CHANGE ORDER APPROVAL FORM

PROJECT: US 1 @ Ratliff Road
Intersection Improvements Project

CHANGE ORDER NUMBER: 05 (Revised)

CONTRACT NUMBER: CM1606

MES @ STA. 20+82.94
 57.58' LT.

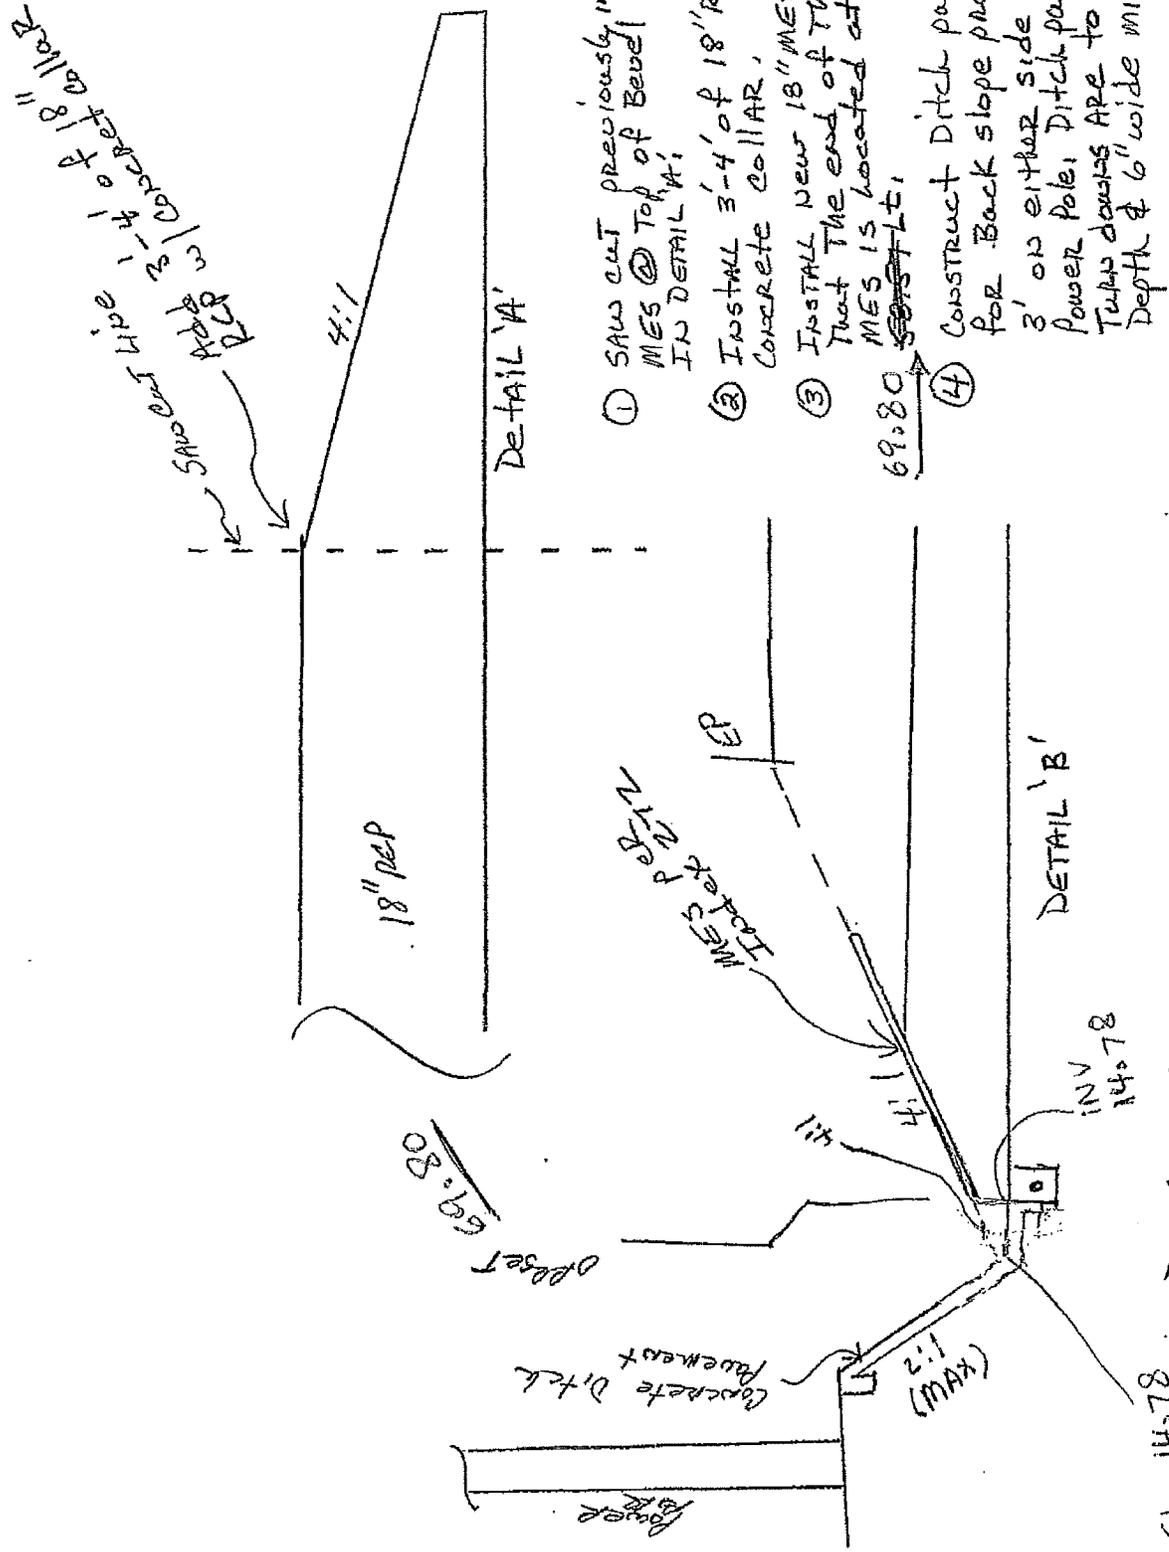
All of your instructions are good, but please see attached with slight modifications. The shown offset in the plans is close to the location of the existing headwall. The correct offset in your detail works out to be 69.80 LT at 4:1 slope. Also, the 4:1 slope is extended to the bottom of the ditch (shown dotted), which leads to a steeper back slope to the concrete ditch...
Let me know if you have any questions.

Attached is the detail for the MES issue on the above referenced project. Please review and provide any comments as necessary.

- ① SAW CUT PREVIOUSLY INSTALLED MES @ TOP OF BEVEL AS SHOWN IN DETAIL 'A'.
- ② INSTALL 3'-4' OF 18" RCP W/ CONCRETE COLLAR.
- ③ INSTALL NEW 18" MES SO THAT THE END OF THE MES IS LOCATED AT OFFSET 69.80.
- ④ CONSTRUCT DITCH PAVEMENT FOR BACK SLOPE PROTECTION 3' ON EITHER SIDE OF EXISTING POWER POLE. DITCH PAVEMENT TYPIC DIMENSIONS ARE TO BE 18" IN DEPTH & 6" WIDE MINIMUM.

STA. 20+82
CONST. 18" MES
FL 14.78
FDOT INDEX 272

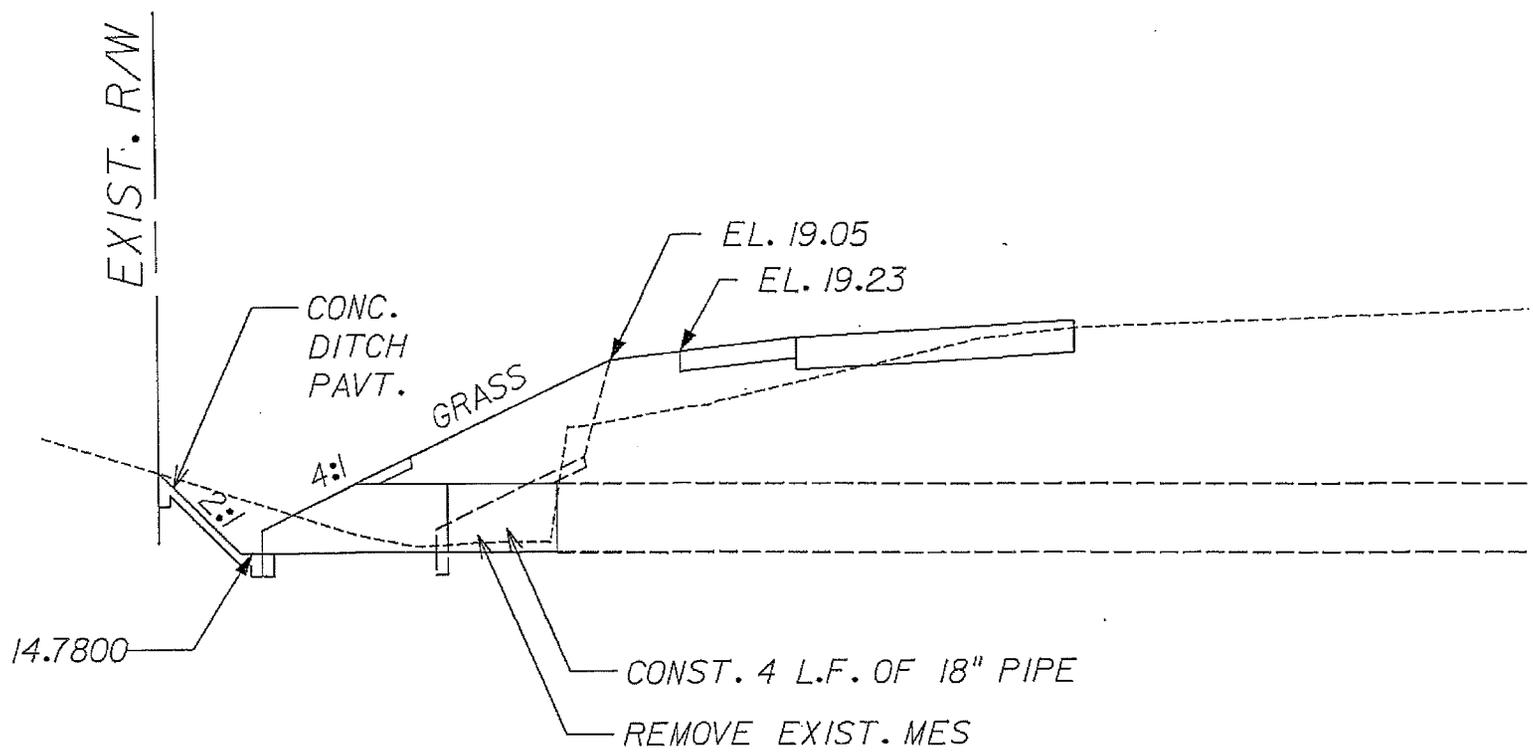
Please use the attached in conjunction with the detail previously provided to re-construct the MES at Sta. 20+82 +/- on the above referenced project.

Attached is the detail I promised you weeks ago for the Ratliff Cross drain....no difference really from what they already have in sketch form.
